VALUE ENGINEERING STUDY

DEPARTMENT OF WATER RESOURCES

FRANKS TRACT PILOT PROJECT SACRAMENTO, CA

Final Report

Alternative No.: RS-01

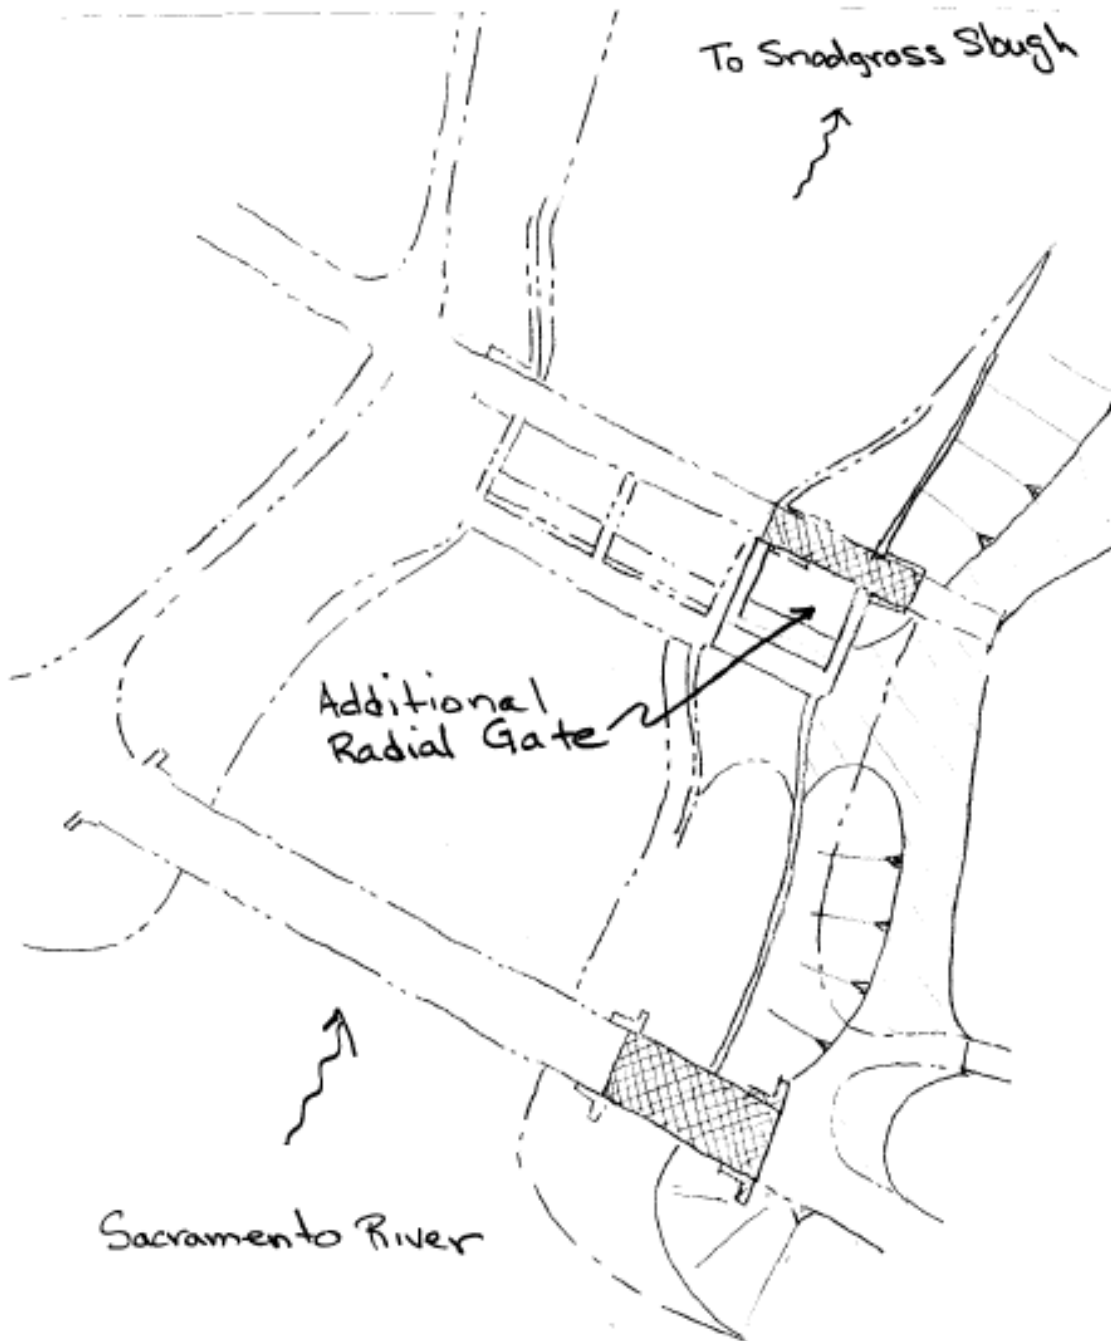
- Refurbishment of the existing DCC gates will add reliability of diversions toward the Delta export facilities
- Increasing the diversion capacity of the DCC will add flexibility to the facility operation schedule by allowing more water diversion to the south, or allowing periodic closure of the gates during the diversion months, while not reducing the total amount of diverted water
- The ability to periodically close the diversion may be used during some periods to reduce entrainment of fish; closure of the DCC gates can be operated on real-time monitoring of fish movements
- The alternative improvements do not impact boat traffic in the area and, therefore, do not require mitigation

Alternative No.: RS-10a

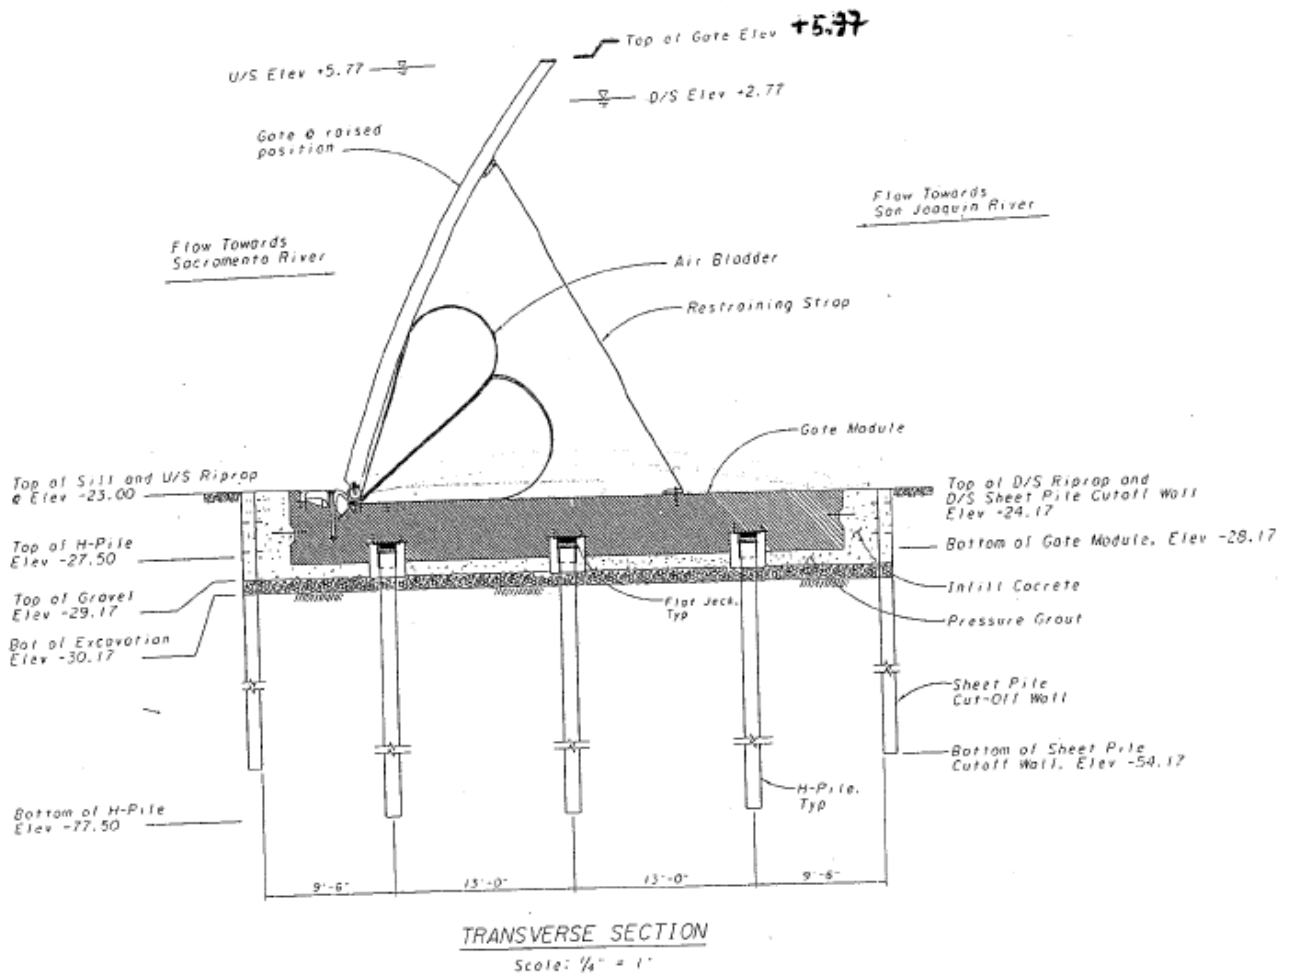
- Bottom-hinged gates without freeboard results in shortening of the leaf (by 1.25 feet) and a slightly narrower sill width; this minor change positively affects the excavation width

Bottom-hinged Obermeyer gates along the Three Mile Slough would be operated at nighttime ebb tides for approximately four hours or at both daytime and nighttime ebb tides for approximately two hours on each tide. DWR should investigate whether this operation will provide the same water quality and, since the fish will be delayed for about two hours twice daily rather than for four hours once daily, if predation may be reduced.

Alternative No.: RS-10b

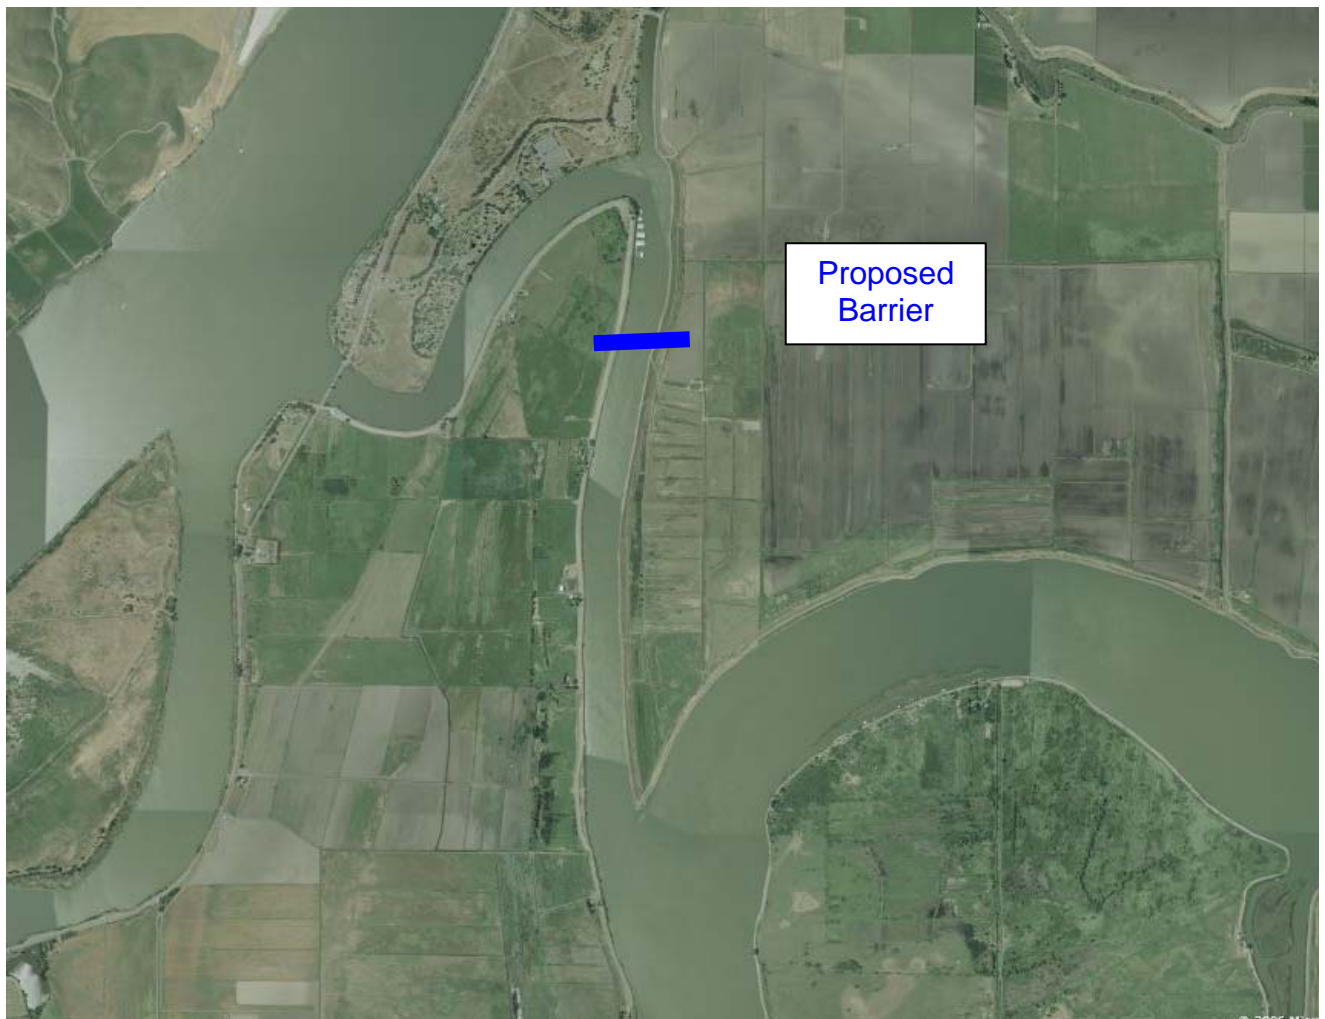
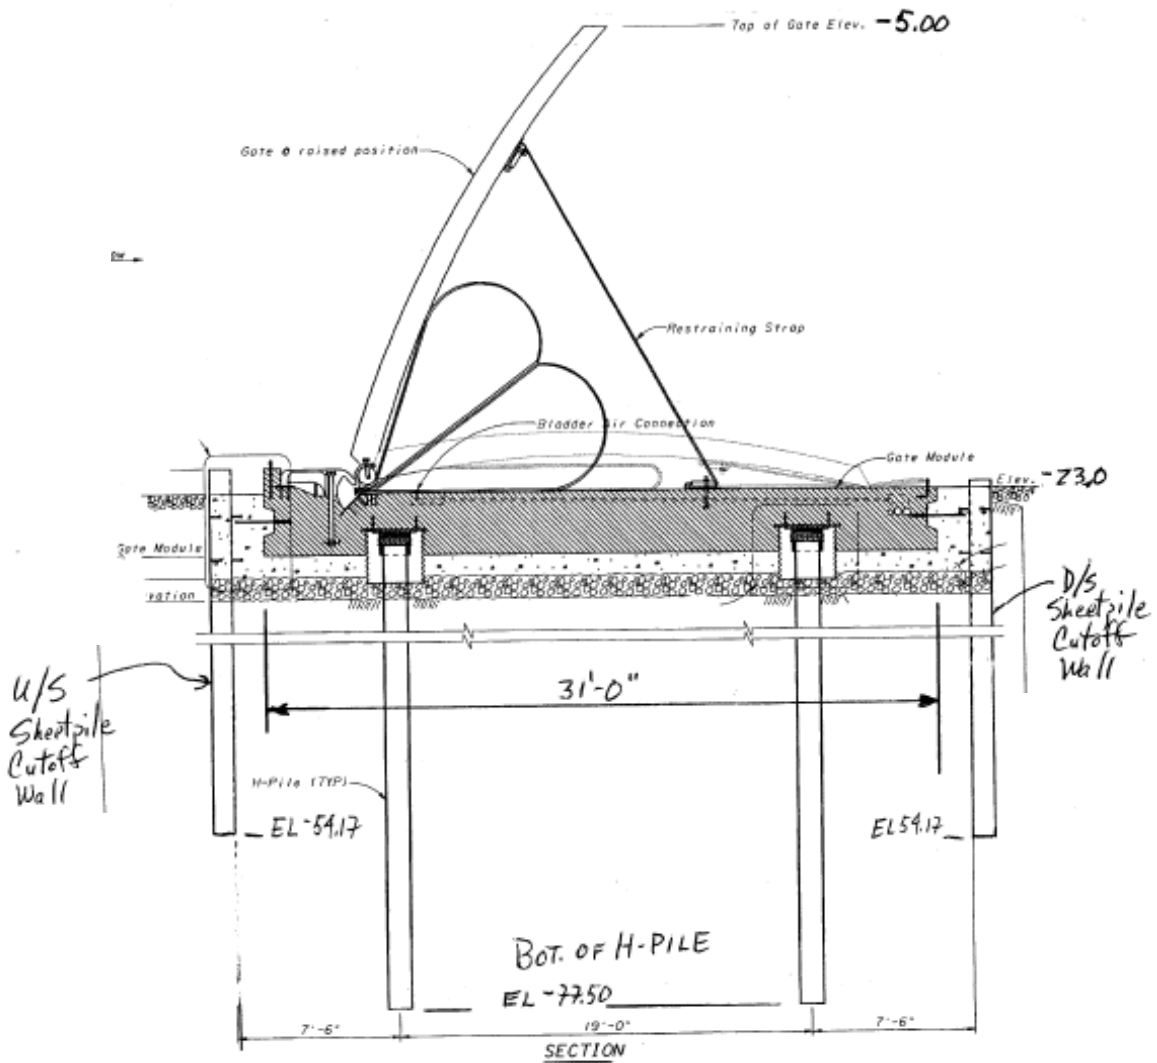
Several marinas exist on or adjacent to Three Mile Slough. The effects of a partial-height gate on boat traffic must be determined. It is possible to allow boat traffic to travel over the gate while the gate is in the raised position, but the results of the hydraulic model must be investigated to determine if the hydraulic jump over the gate is significant to boat safety.

Alternative No.: RS-34

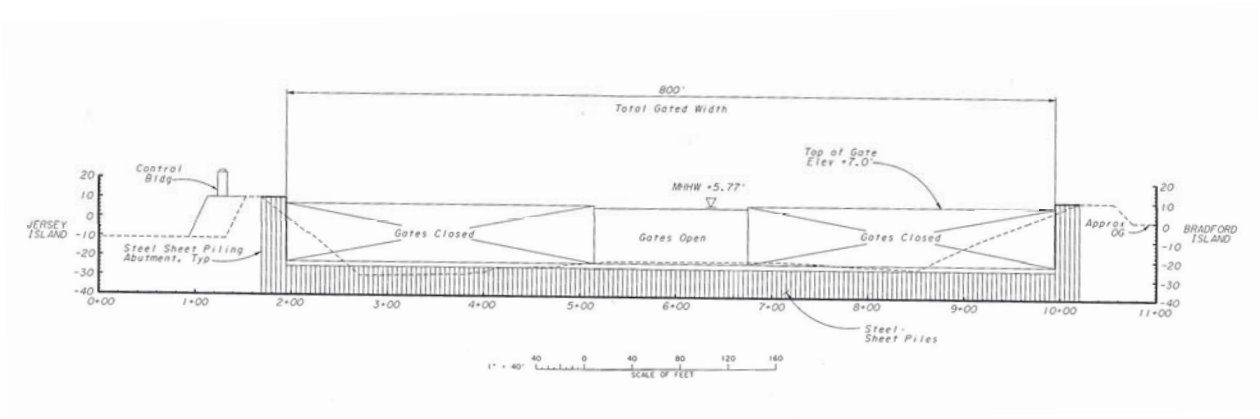
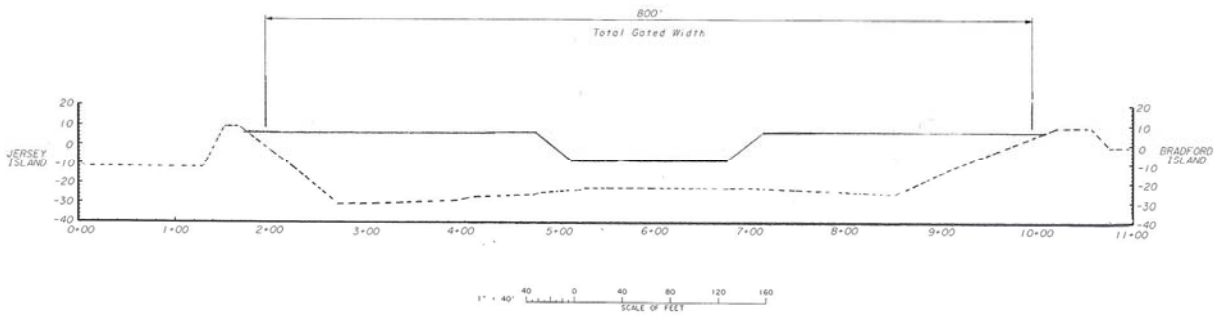
In terms of navigation impacts to boats, neither the gated control structure or the Rock barrier is designed with boat locks. Although not included in the original concept of the gated control structure, a boat lock could be added relatively easily. The rock fill barrier has a notch in the middle of the barrier to allow recreational boats to pass.

Alternative No.: RS-41a

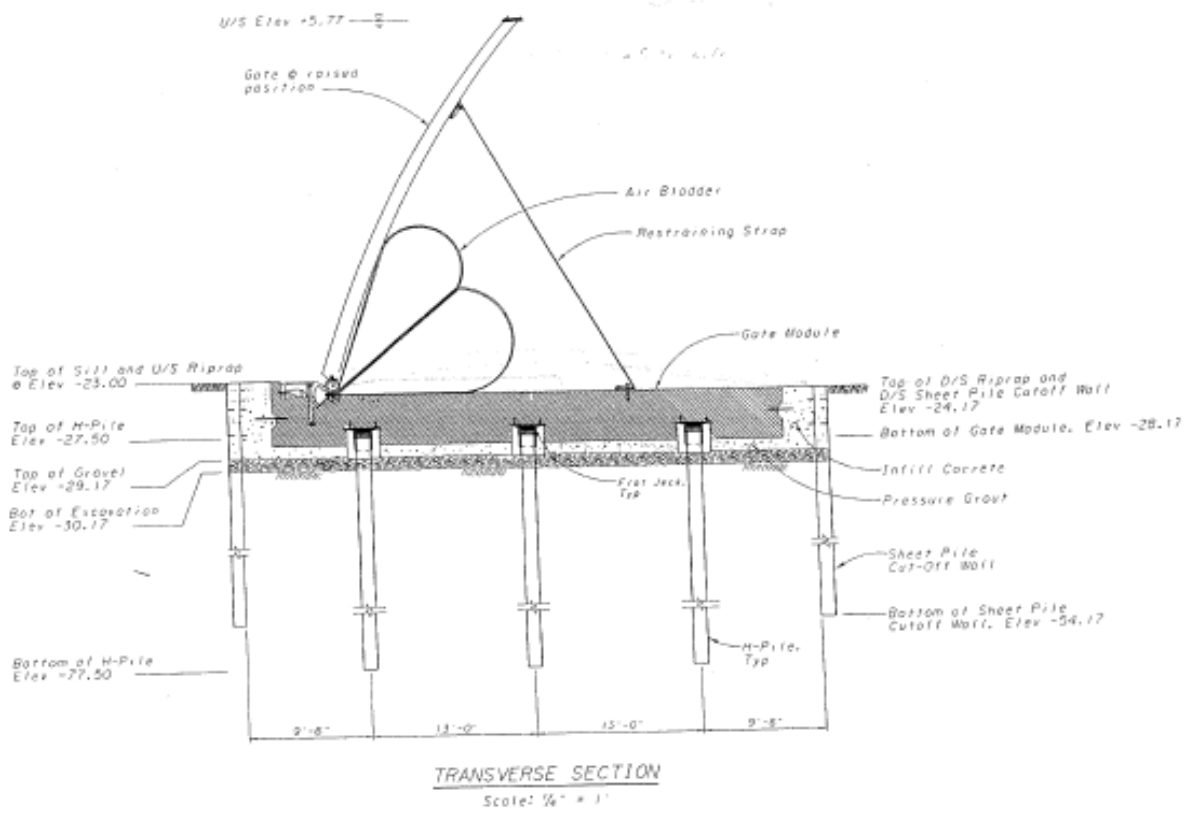
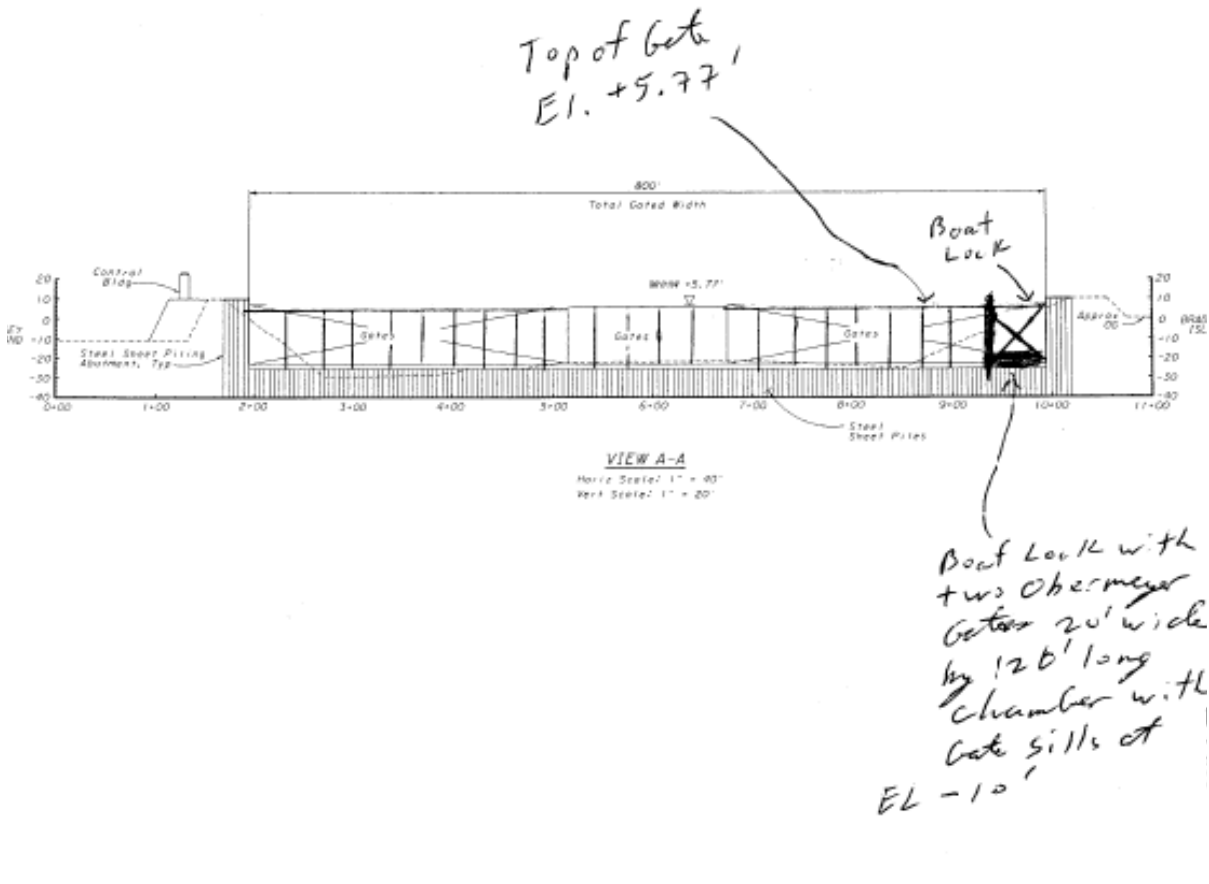
This 28.77' high Obermeyer gated barrier is 800 feet wide across the West False River, and is open for a continuous 12 hours and closed 12 hours per day. It includes a boat lock within the 800' width, and the lock would be operable when the gates are up. The boat lock is assumed to use two 20' wide Obermeyer gates (one at each end), with a 120' long lock chamber, with a gate sill elevation at approximately El. -10'. The lock chamber is assumed to use Z-sheet piles for the river wall, and a rip-rapped levee slope for the land wall.

The top of the barrier gates is at El. +5.77' and the top of the sill is at El. -23.0'. The gate barrier would be built "in-the-wet" using off-site prefabricated sill/gate assemblies that would be delivered to the site by barge, lifted by cranes, and set underwater on pre-driven pile foundations and between sheet pile cut-off walls. Underwater grout would be used to connect the precast sills to the pre-installed foundations.

Alternative No.: RS-41b

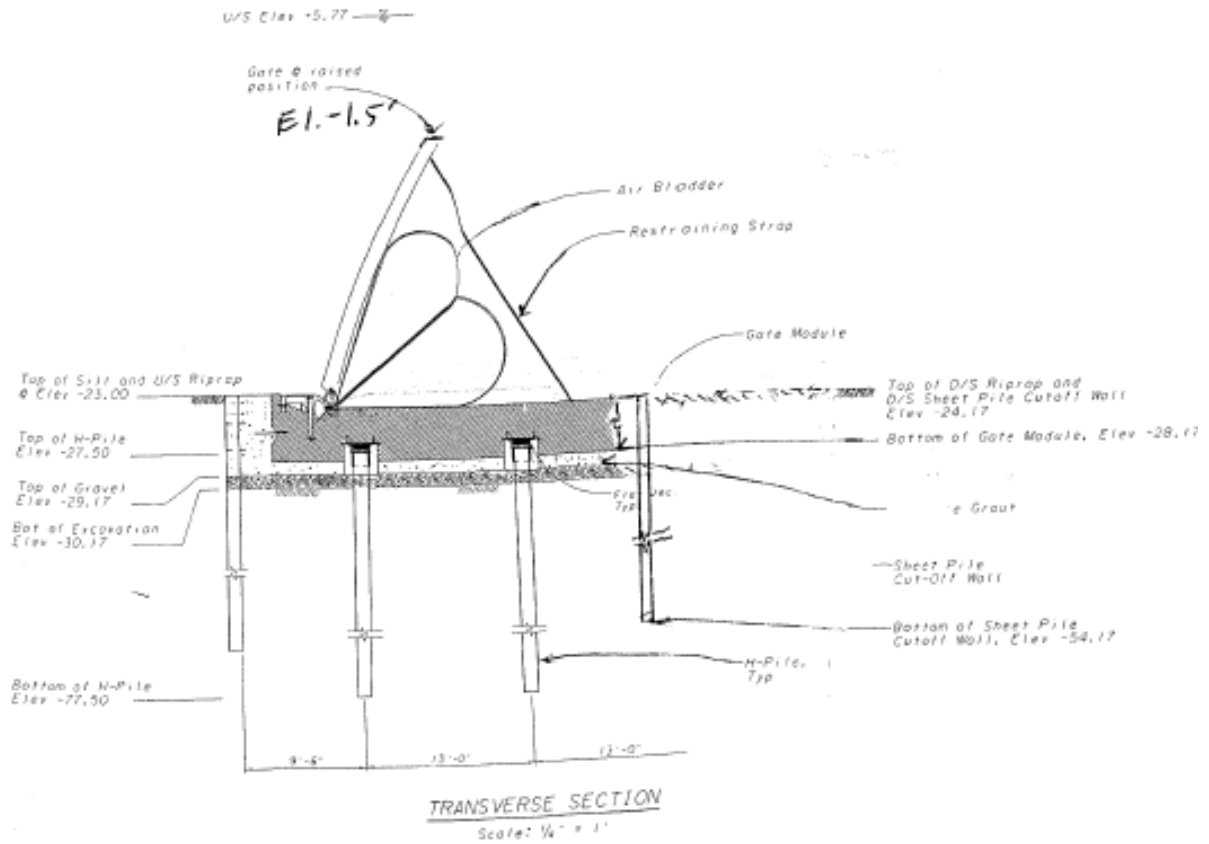
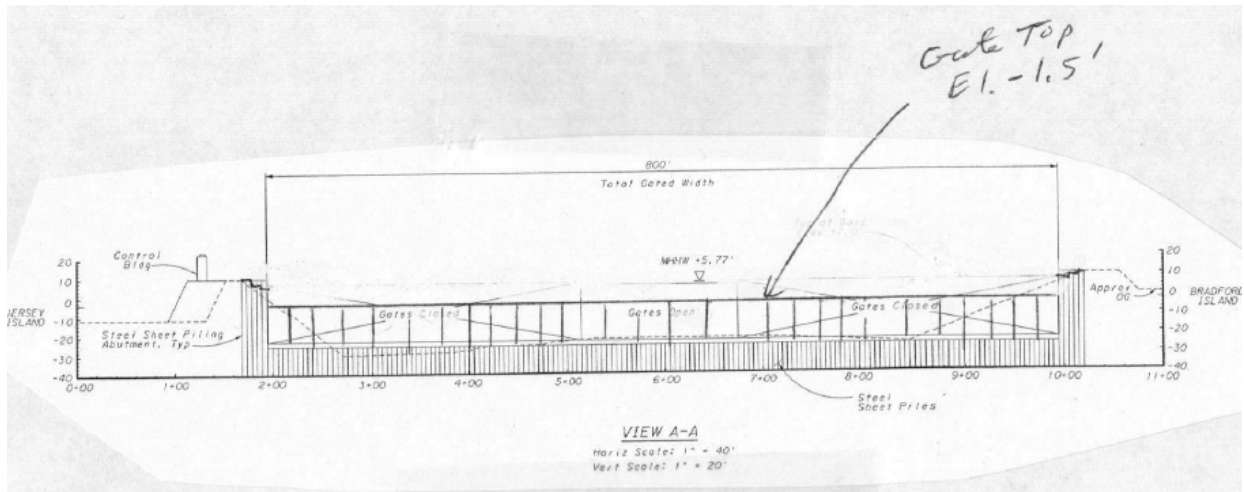
This 21.5' high Obermeyer gated barrier is 800' wide across the West False River, and is open for a continuous 12 hours and closed 12 hours per day. The top of the gate is at El. -1.5' and the top of the sill is at El. -23.0'. The abutments stair-step down from the top of the levee to El. +7.0. The gate barrier would be built "in-the-wet" using off-site prefabricated sill/gate assemblies that would be delivered to the site by barge, lifted by cranes, and set underwater on pre-driven pile foundations and between sheet pile cut-off walls. Underwater grout would be used to connect the precast sills to the pre-installed foundations. It is assumed that the tops of the partial-height gates will be low enough so that floating protective booms will not be needed to protect the gates from pleasure boat impacts (note that passage of deep draft vessels would need to be scheduled for periods when the gates are in the down position). It is further assumed that having the top of the partial-height gates at El -1.5' will roughly correspond to the 20% open option already modeled by DWR; however, if this is verified by future numerical modeling then the elevation of the top of the partial height gate should be adjusted until this assumption is correct.

It should be noted that the presence of any barrier will increase the duration of increased hydraulic head on the levees which: a) may slightly reduce the stability of the levees and b) may slightly increase water seepage into adjoining farm lands (requiring more pumping). Note that the barrier uses gates along its full length in order to maintain a flood neutral condition for the river when the gates are in the down position. The original barrier may need to have fish ladders and/or fish culverts added in order to receive permits; however, it is believed that proposed alternative may not need these features.
